**THE IMPROVEMENTS OF
PROCTOR ROAD
FROM REDWOOD ROAD TO CAMONO ALTA MIRA
CASTRO VALLEY, ALAMRDA COUNTY, CALIFORNIA
SPECIFICATION NO. 2491**

TO ALL PROSPECTIVE BIDDERS for the above project, notice is hereby given that the following changes, modifications, corrections, clarifications, and additions as hereinafter set forth shall apply to the plans and specifications described herein and shall be made part thereof and subject to all requirements as if originally specified or drawn.

Specification No. 2491

DATE: MAR 2025
WORK ORDER NO: R32144
SPECIFICATION NO: 2491
SHEET NO: 20 OF 59
FILE NO: U-639

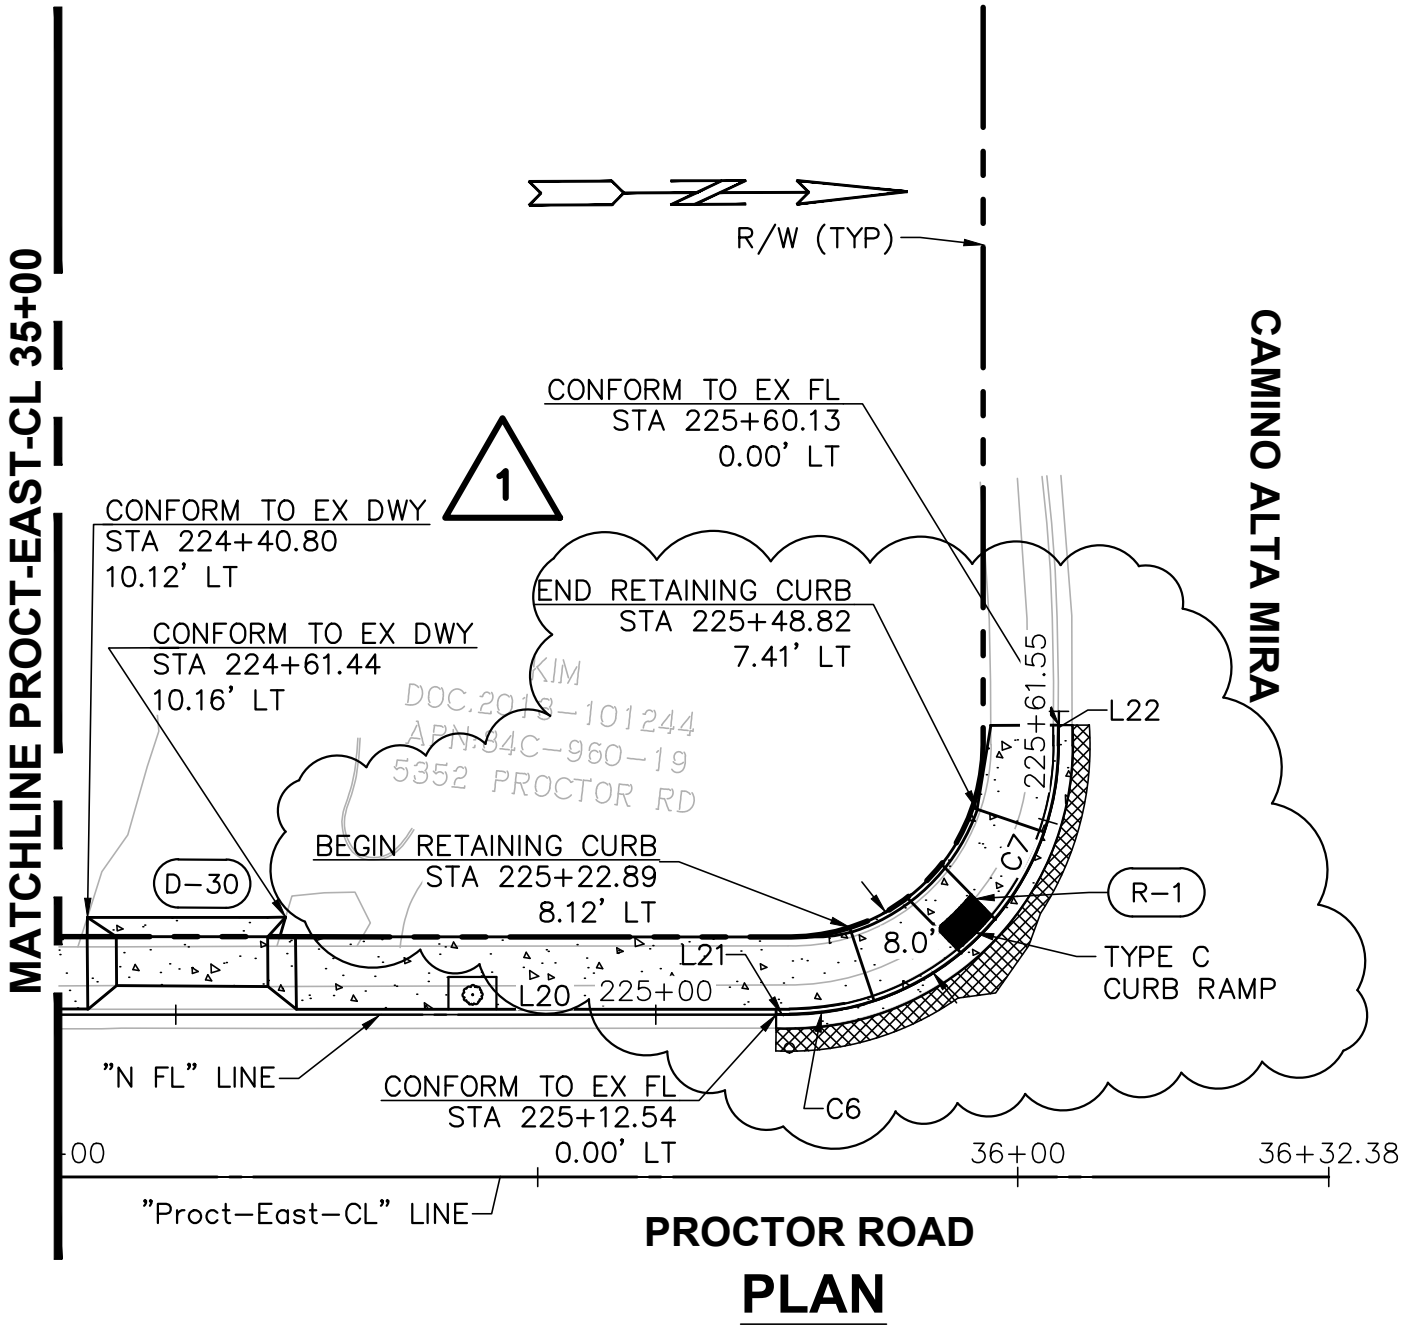
NO.	DESCRIPTION	BY	DATE	APPROVED
1	REVISED CURB RAMP DETAILS	JK	4/8/25	JC

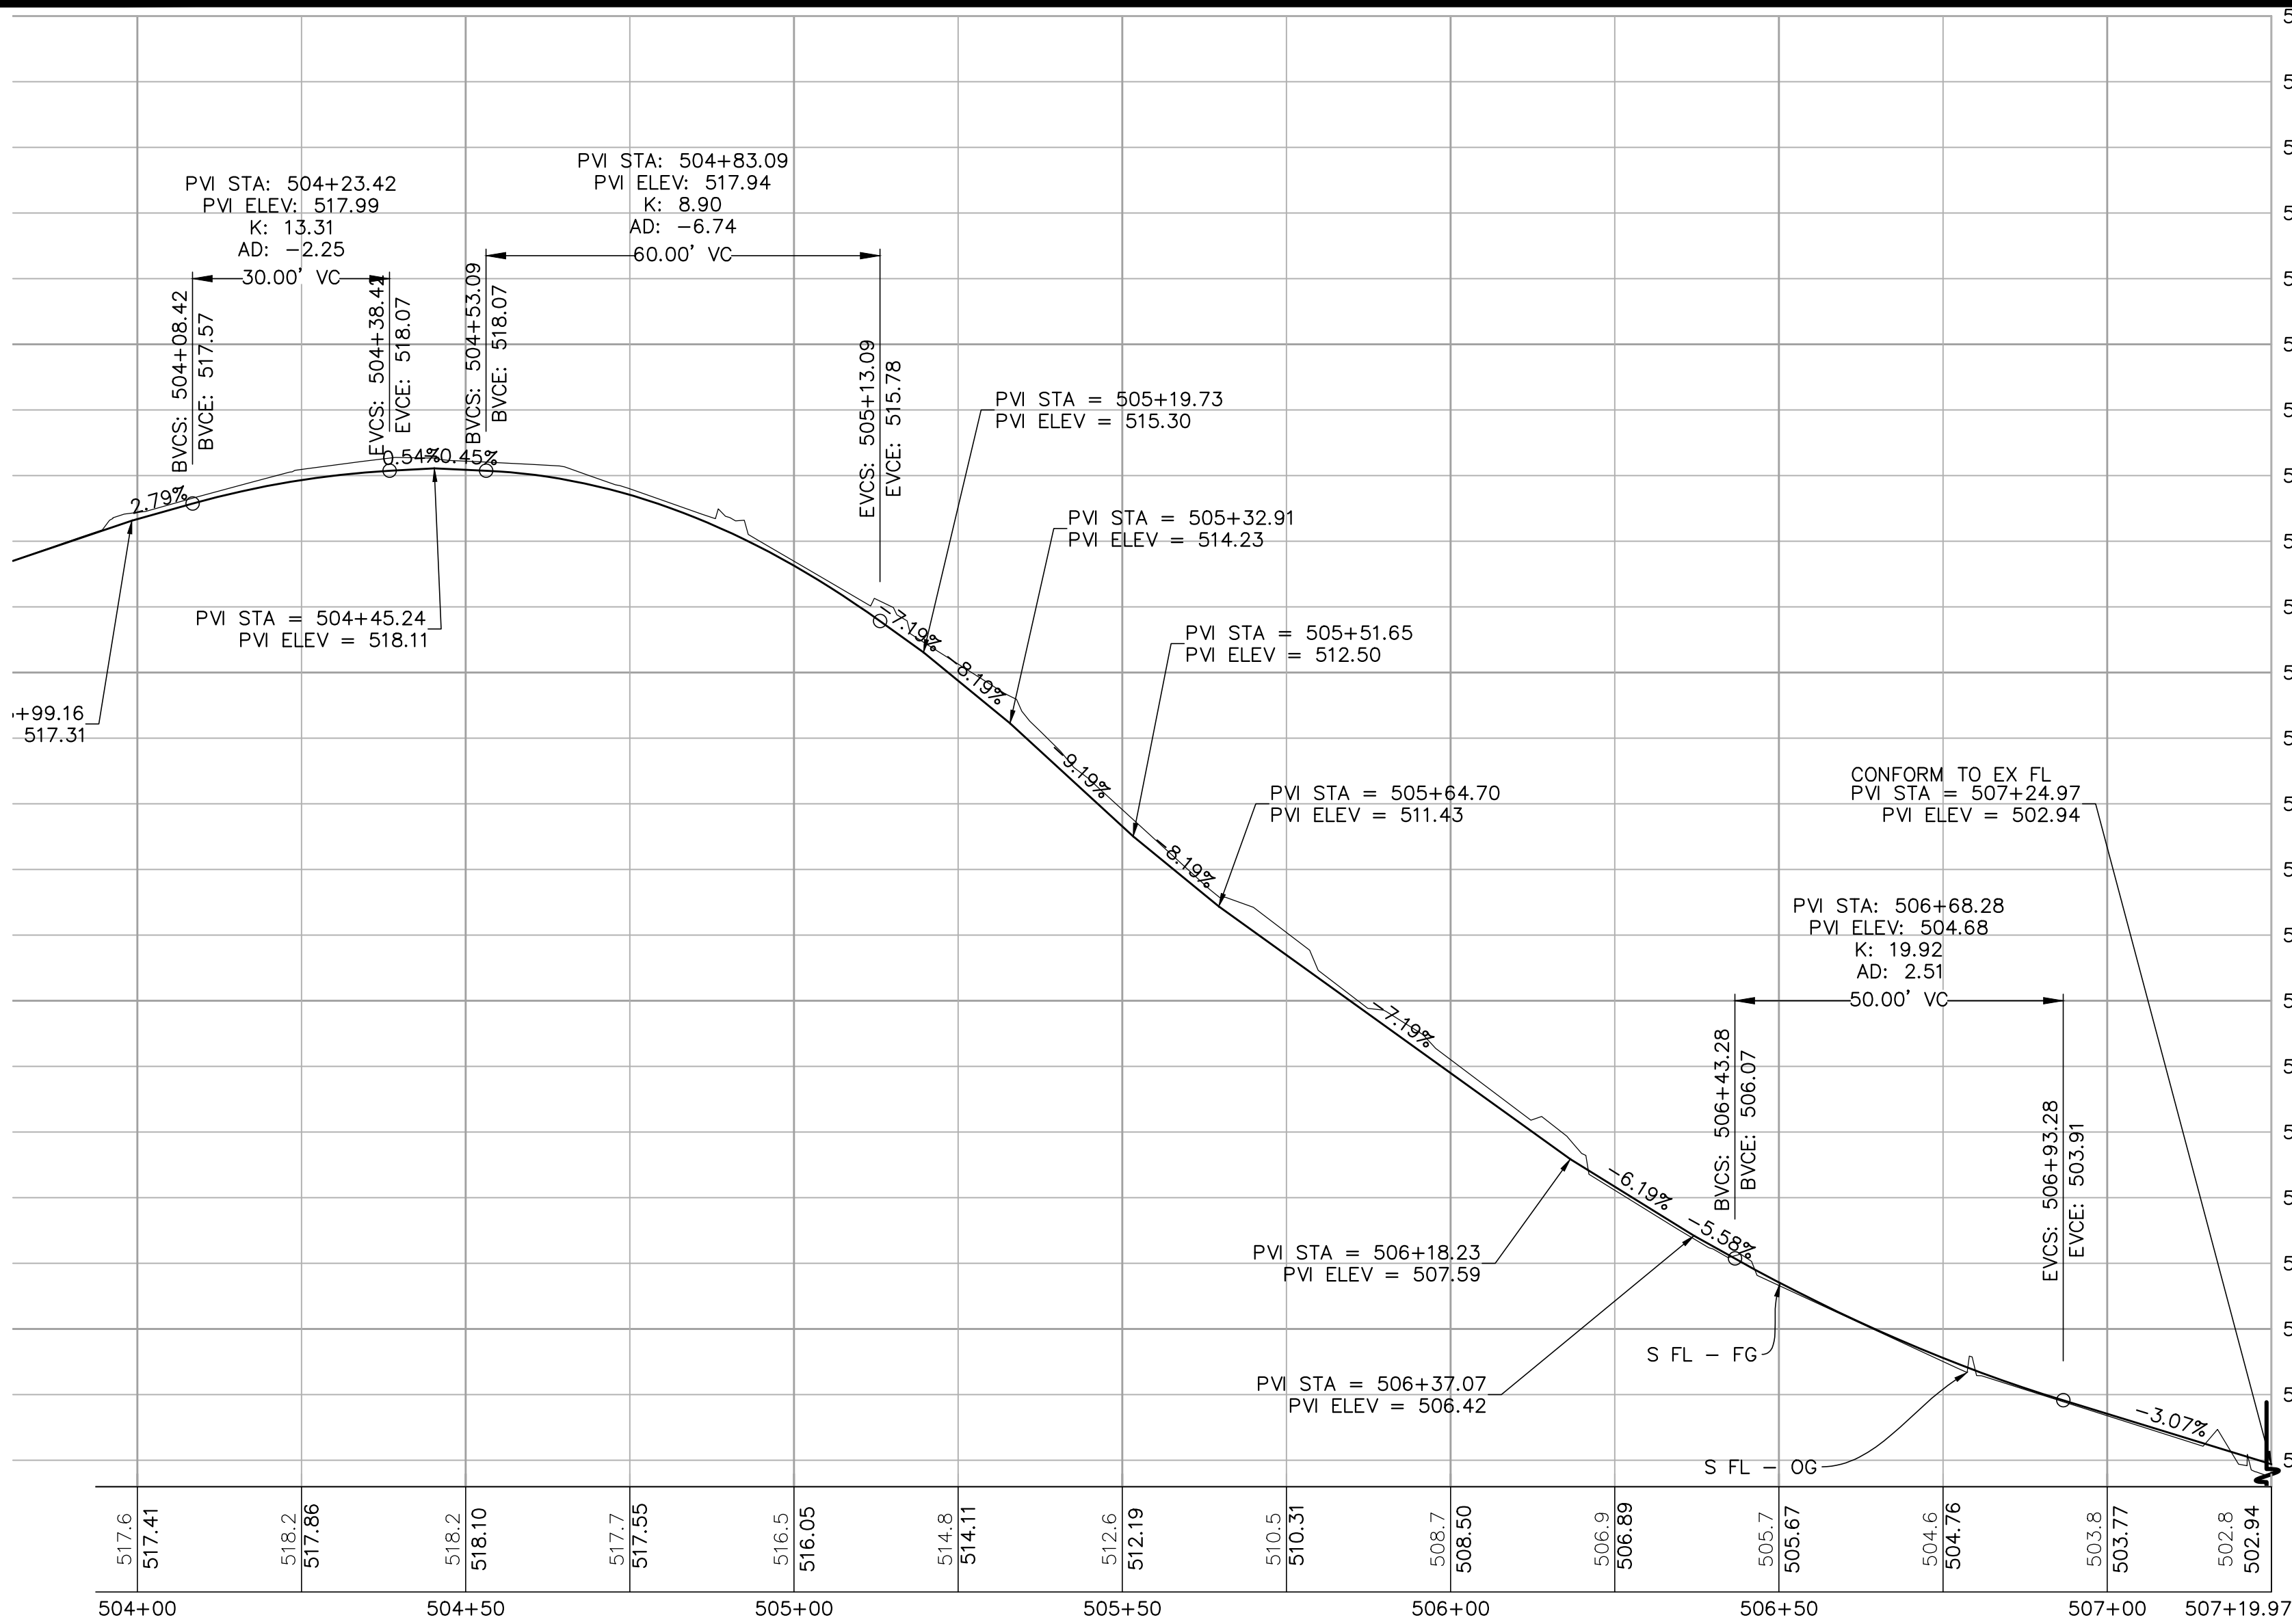
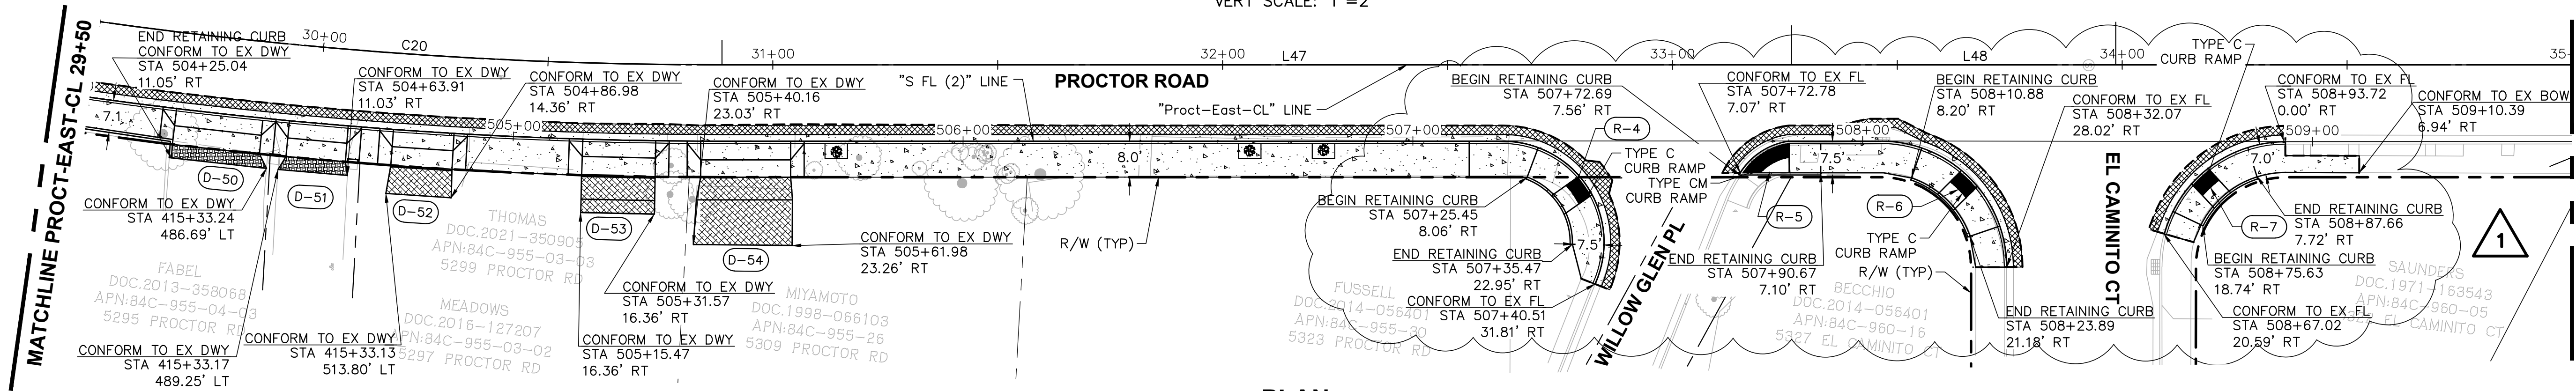
<table><tr><td>△</td><td></td><td></td><td></td></tr><tr><td>△</td><td>REVISED CURB RAMP DETAILS</td><td>JK</td><td>4/8/25 JC</td></tr></table>
